Subject: FW: AL/20/18/OUT - Land at Bridge Cottage & The Old Cottage, Lidsey Road

Technical Note

The Old Cottage Lidsey

TN_SGR_TOC_101117-3_V2

Updated Highway Design Plan (OCL/SR/701 Rev. No. C)

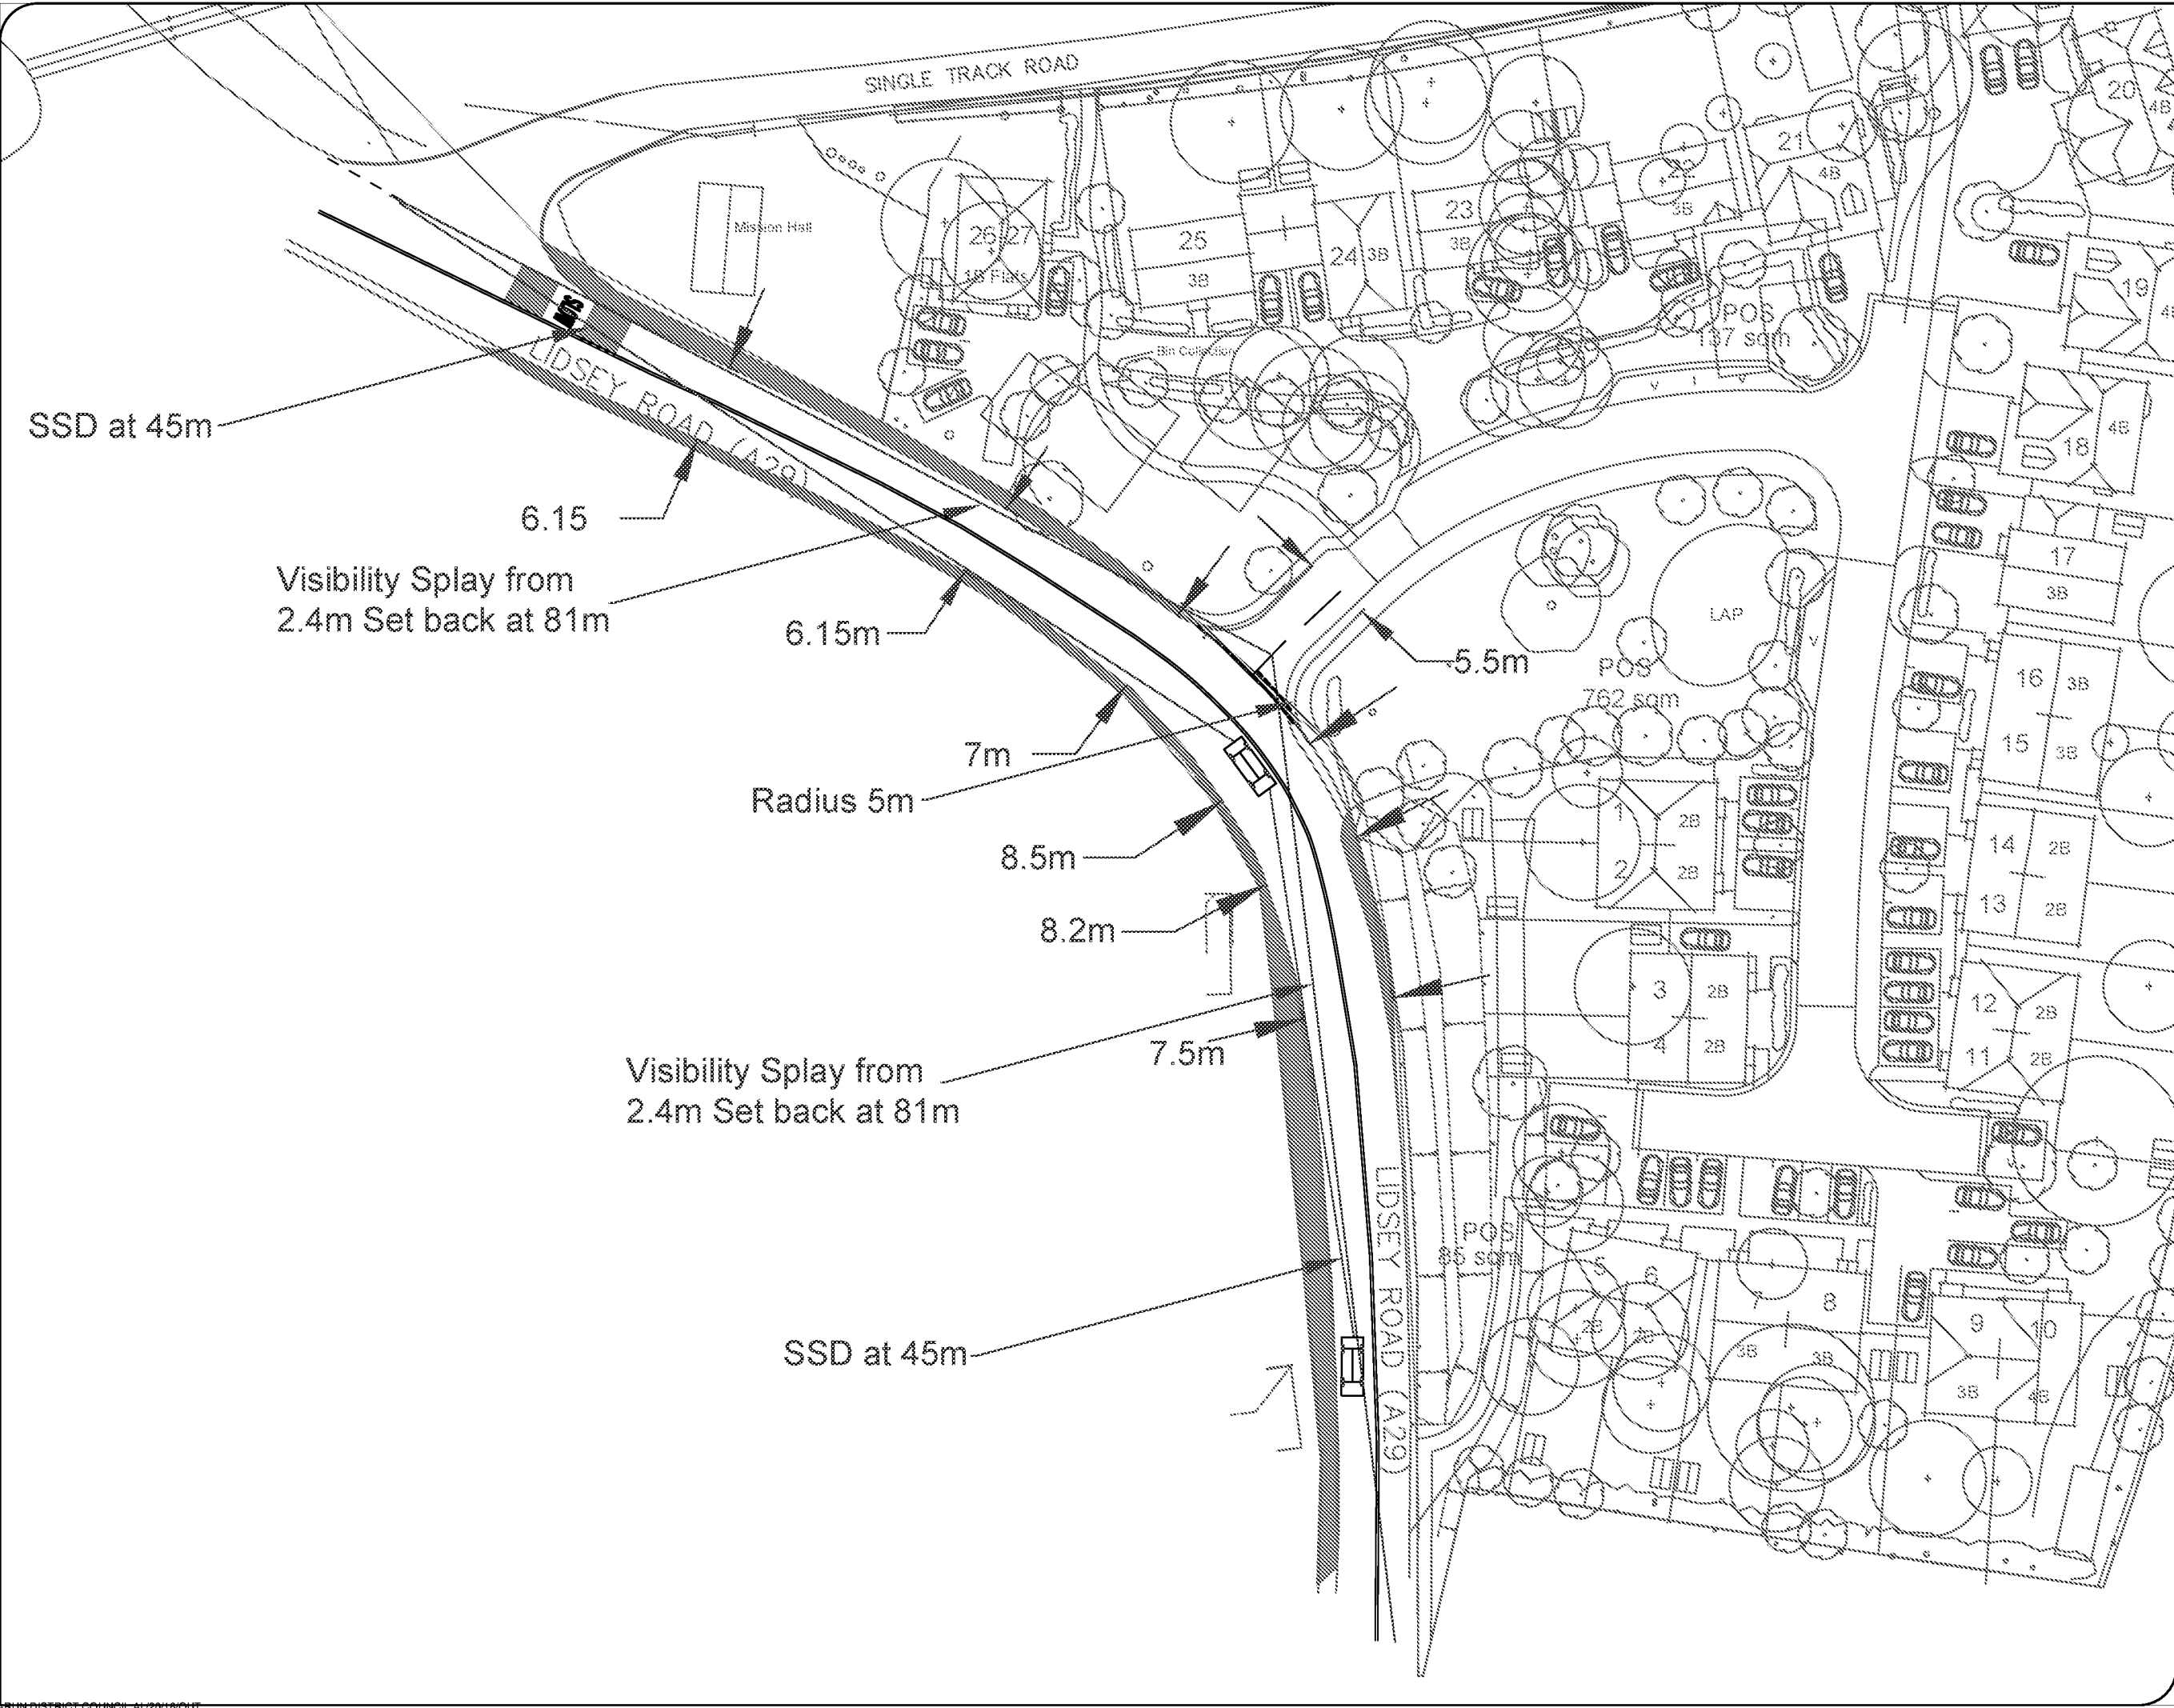
As mentioned above, vehicular access is shown directly off the A29 on the apex of a bend in the road. The access measures 4.8m wide with what appears to be 5.0-6.0m bellmouth radii (this should be clarified and marked-on a plan). Visibility splays are taken from a 2.4m 'x' distance with major road ('y'), with the applicant's Transport Consultant stating that splays of 106m in the leading traffic direction can be provided - looking west from the access - (98m scales on the plan) and 150m in the trailing direction - looking south - (79m scales on the plan). Forward visibility (i.e. that required for drivers of vehicles turning right and left into the site and corresponding visibility for drivers already on Lidsey Road coming-across them - from both north and south) is stated as being 81m (although approximately 60m scales from the drawing between a right turning vehicle and driver of a vehicle travelling southbound). No northbound forward visibility splay is shown for vehicles driving northwards coming across a vehicle turning right into the site.

Given the lack of clarity including lack of marked-on dimensions and visibility splays - it is not known what can actually be provided - both on and off-site. For the CHA to consider the matter further, the above matters should be attended to - a summary of which is provided below (other requirements are summarised elsewhere in this report under relevant sections):

- The dimensions of bellmouth radii of new junction
- The achievable visibility splays taken from 2.4m 'x' distance with dimensions marked-on
- The forward visibility both for vehicles travelling north AND south encountering a vehicle waiting to turn into the site with dimensions
- Dimensions of carriageway at and on the approach to the site entrance (and site entrance itself)

With regard to what design guidance and/or standard should be used, based on the speed survey data alone, this suggests that it is appropriate to use MfS2 given the closeness of the recorded speeds in relation to the criteria in that document. What is not clear, however, is the interpretation of the visibility splays and how they are plotted on the application site access drawing (as already mentioned above). Also, the position of the right-turning vehicle (car) could – in practice – vary. As such, the applicant should re-draw the splays, ensuring they are properly plotted with dimensions marked on them and also provide two plots of the right-turning vehicle - one where it is at present and the other with it slightly further forward. As already mentioned above, forward visibility and Stopping Sight Distance (SSD) splays should also be marked-on (for users of the access and for those encountering the turning vehicle from both directions) as should the dimensions and details of the proposed changes to the road and its markings in this location. Areas where vegetation is prevalent should also be marked on more clearly.

- Visibility information and SSD to right turning vehicles as required as above
- Vegetation areas required for visibility purposes shown more clearly
- Road markings that are proposed at and on the approaches to the new access point and how these comply with the Traffic Signs Manual
- A Design Commentary setting-out how the design complies with guidance and/or design standards

2.1.1 Updated plan (OCL/SR/701 Rev. No. C) is attached, as Appendix 2. The drawing incorporates dimensions of the new access, carriageway widths, and forward visibility.

2.3.1 Updated plan (OCL/SR/701 Rev. No. C) shows the visibility splays, vegetation that falls within the limits of the adopted highway that can be cleared to further enhance forward visibility, and roads markings. Any minor amendments to the access configuration can be addressed as necessary via the Stage 2 Road Safety Audit.
